Town of Hilton Head Island
**William Hilton Parkway Gateway Corridor
Independent Review Advisory Committee**
Monday, April 17, 2023, 1:30 p.m.

TO: William Hilton Parkway Gateway Corridor Independent Review Advisory Committee
FROM: Shawn Colin, Assistant Town Manager – Community Development
CC: Marc Orlando, Town Manager
CC: Josh Gruber, Deputy Town Manager
DATE: April 17, 2023
SUBJECT: William Hilton Parkway Gateway Project Overview

Figure 1 - Lane Geometries and LOS – Preferred Alternative 4A

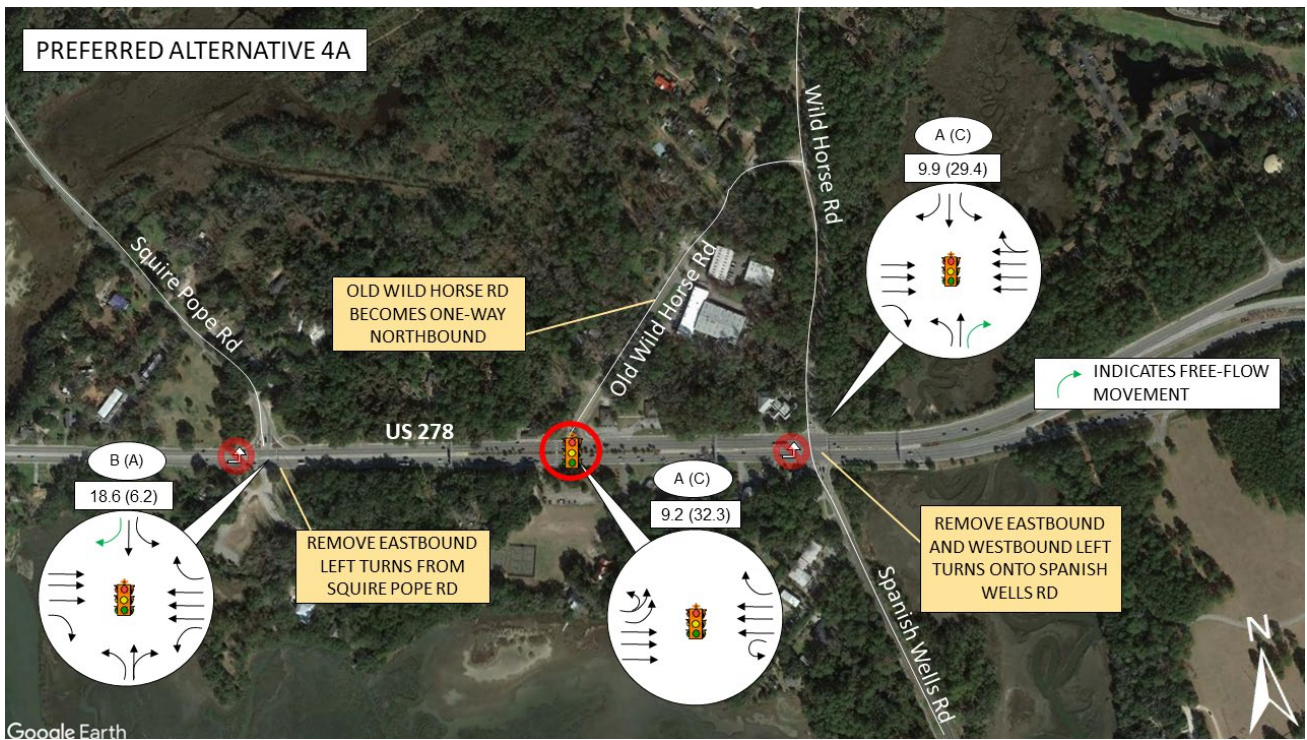
The preferred alternative presented at the Public Hearing proposed to remove the eastbound left turn lane from US 278 onto Squire Pope Road, remove the eastbound and westbound left turn lanes onto Wild Horse Road and Spanish Wells Road, and to add a signal at Old Wild Horse Road to facilitate u-turn movements. This configuration of two- and three-phased signalized intersections will work together as a system to help improve the overall intersection operations along this segment of US 278. The lane geometries and levels of service (LOS) are provided in **Figure 1**.

Figure 2 - Lane Geometries and LOS – Option 1

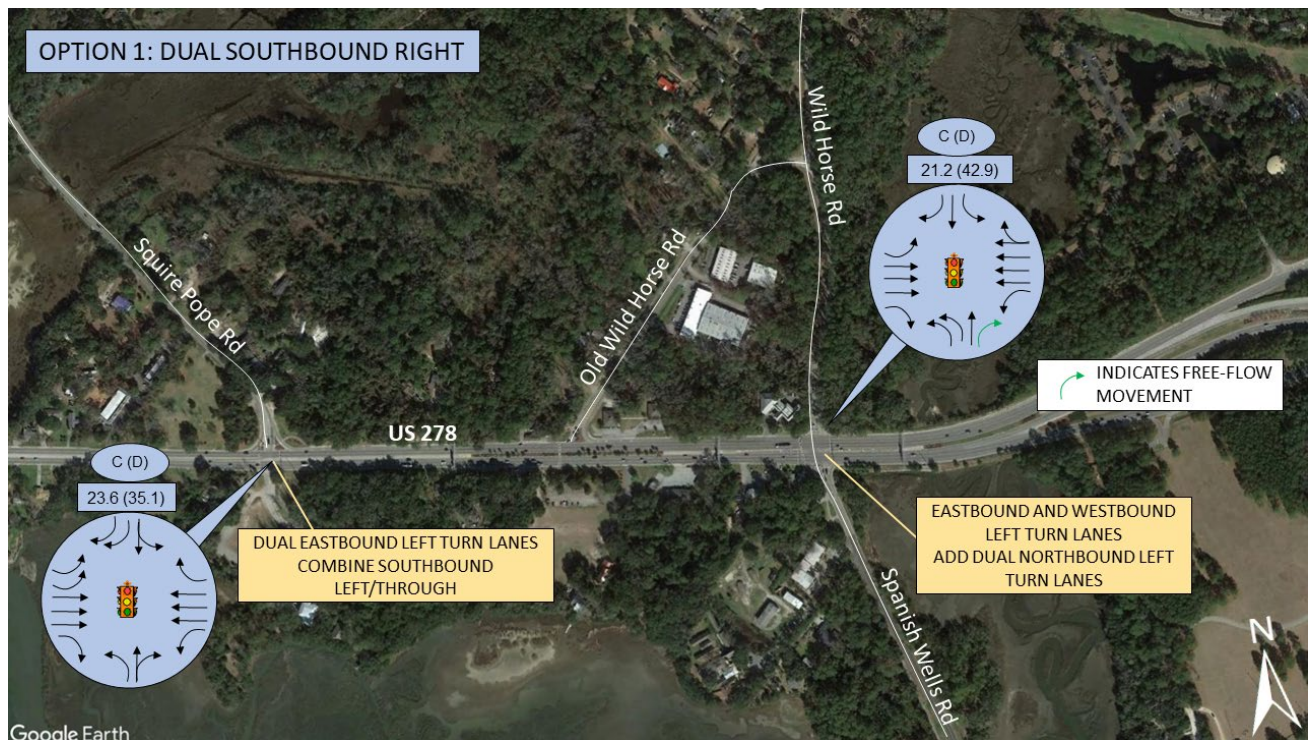
Figure 2 shows the lane geometries and LOS results for Option 1. **Table 3** summarizes the operational analysis of the intersections. In the AM peak hour, Squire Pope Road and Spanish Wells Road operate at LOS C. In the PM peak hour, both intersections operate at LOS D.

Figure 5 - PM Peak Hour Eastbound Progression - Preferred Alternative

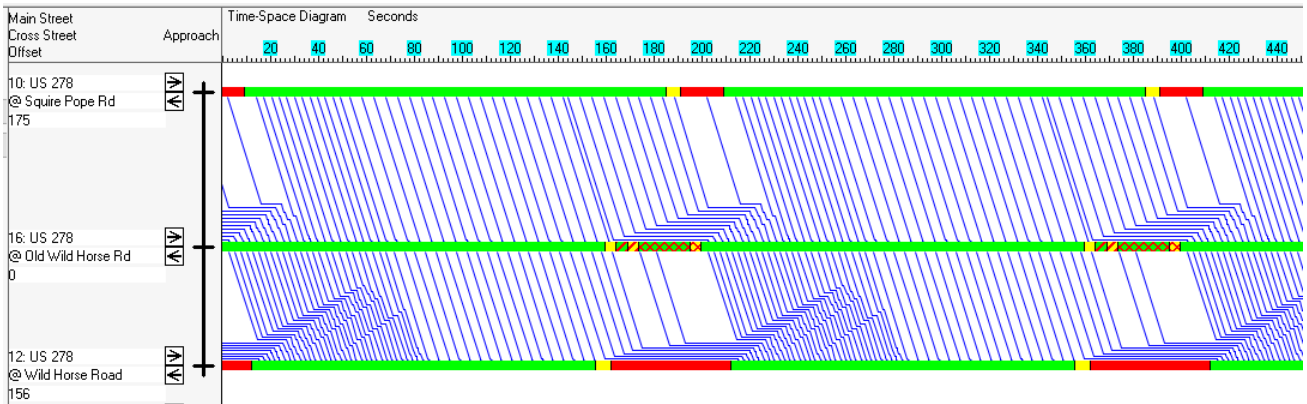
Figure 5 shows the PM peak hour eastbound progression for the preferred alternative. The width of straight lines is approximately 70 seconds. Some vehicles will get stopped at the Old Wild Horse Road signal to allow for the protected u-turn movement phase, indicated by the hatched areas in the green horizontal line. However, because the signals are coordinated and consist of two- and three-phases, once the eastbound traffic gets a green, the queues dissipate at Spanish Wells Road and vehicles can travel unimpeded for 70 seconds.

Figure 6 - PM Peak Hour Eastbound Progression - Option 1

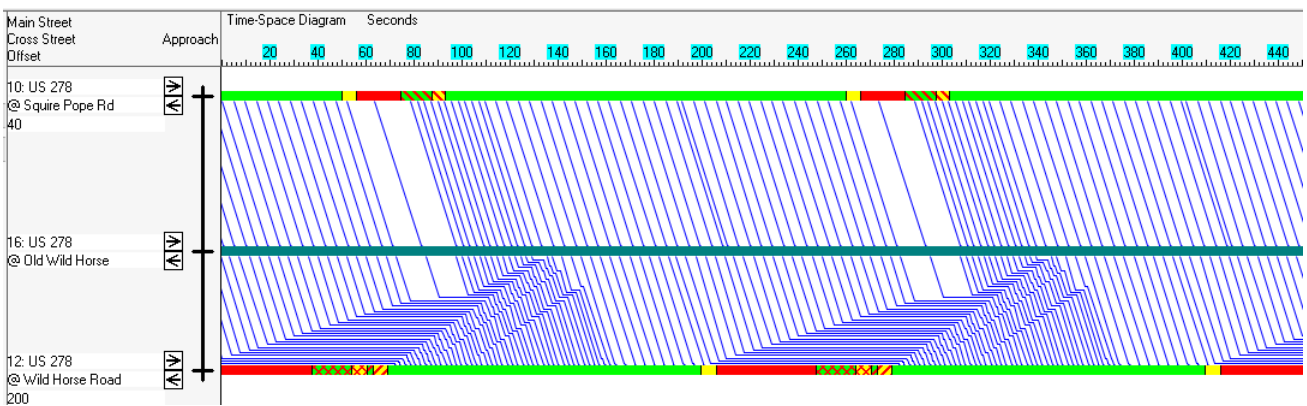
Figure 6 shows the eastbound progression for Option 1. **Figure 7** shows the eastbound progression for Option 2. When compared to the preferred alternative, these alternatives show a much longer queue at Spanish Wells Road. Vehicles begin stacking when the eastbound direction receives a red light. When the light turns green, the front of the queue begins to dissipate, but the back of the queue does not flush out until halfway through the green phase. Although the signals at Squire Pope Road and Spanish Wells Road are also coordinated, they are both four-phase signals that require protected phasing for eastbound and westbound left turns from US 278 (as indicated by the hatched areas within the green horizontal line), which take away from the green time for through traffic along US 278.

Figure 7 - PM Peak Hour Eastbound Progression - Option 2

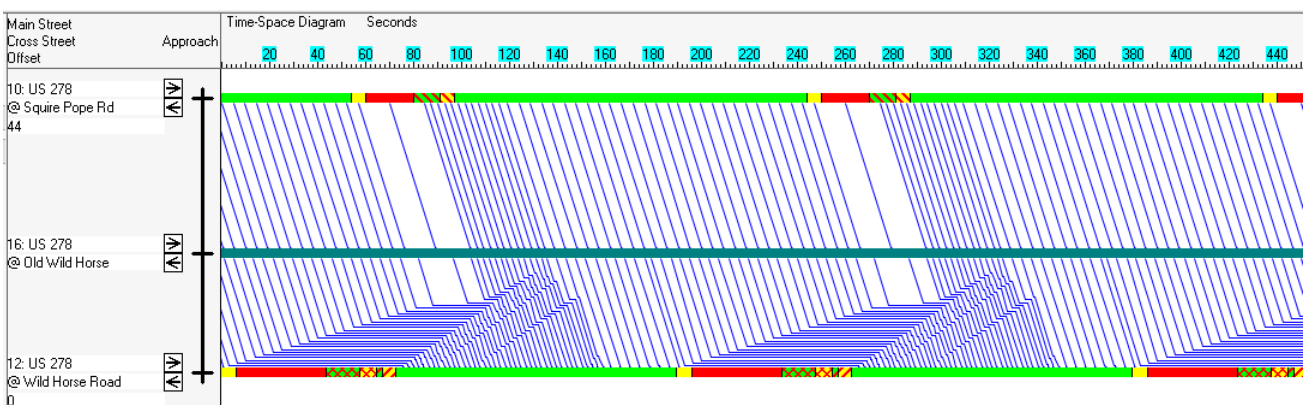
In the eastbound direction during the PM peak hour, Options 1 and 2 have an unimpeded time of approximately 35 and 30 seconds, respectively. This indicates that although there is some delay encountered with the additional signal at Old Wild Horse Road, the overall progression of through traffic is better in the preferred alternative.

Figure 8 - PM Peak Hour Westbound Progression - Preferred Alternative

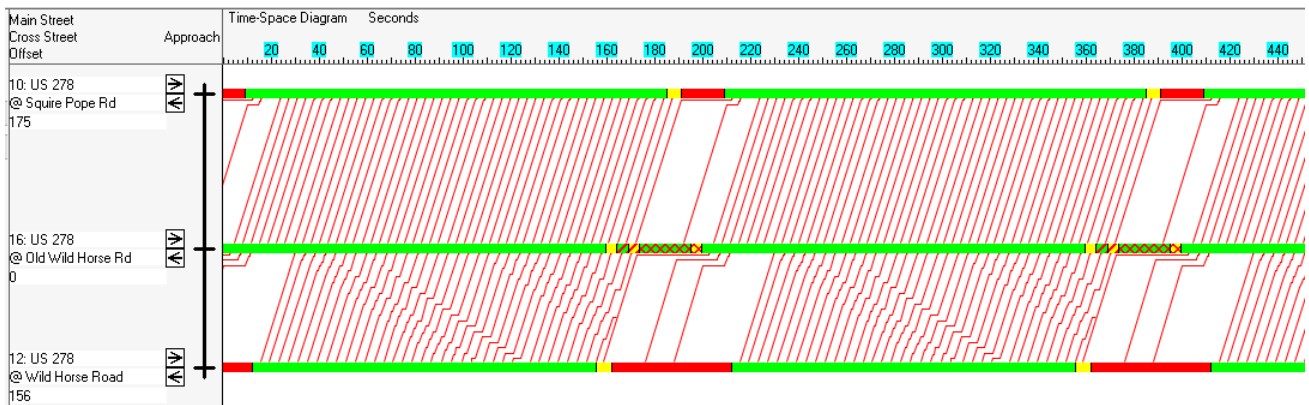
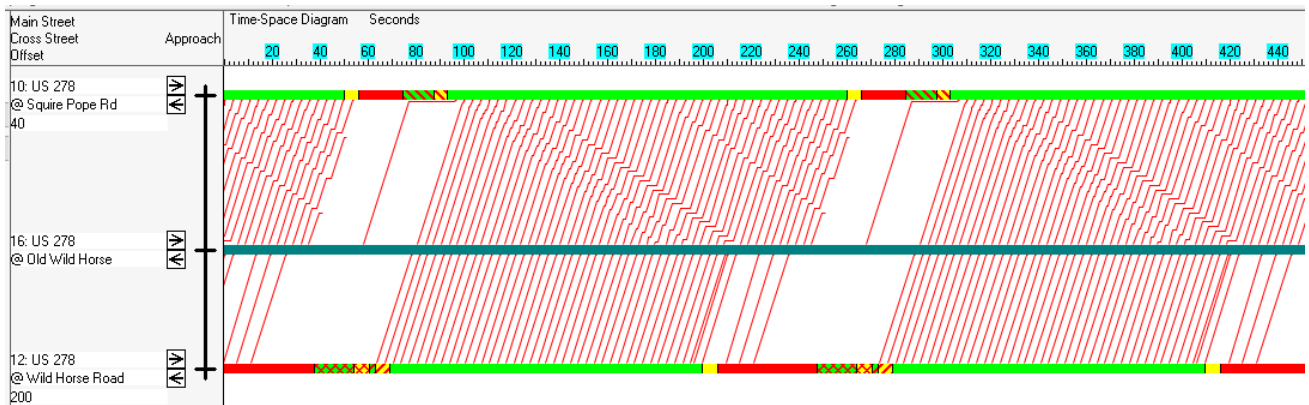
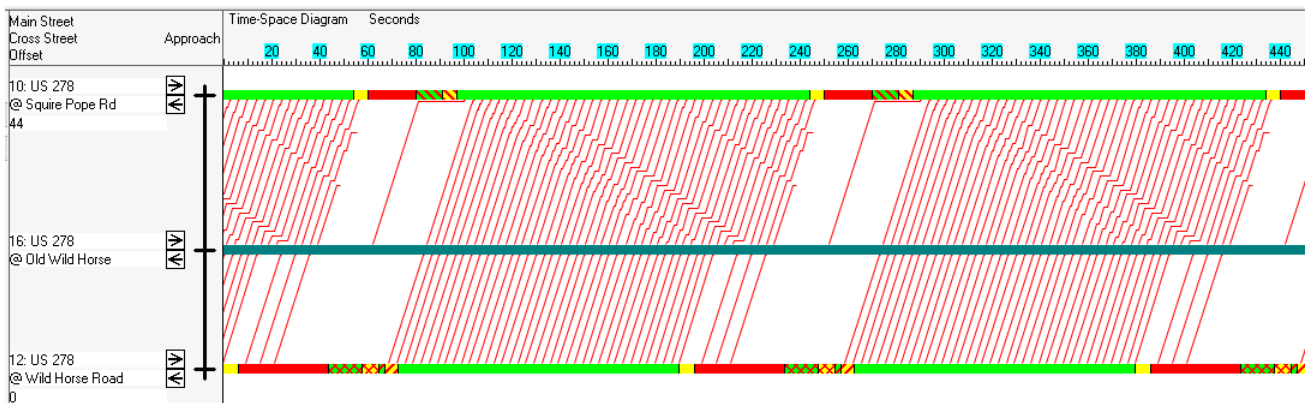
Figures 8-10 show the time-space diagrams for the PM westbound direction. It is often difficult to achieve progression in both directions along a corridor within the same time period. During the PM peak hour, westbound is the peak direction and therefore the signal coordination is optimized in this direction. The progression in the westbound direction in the PM peak hour is essentially the same for all three alternatives.
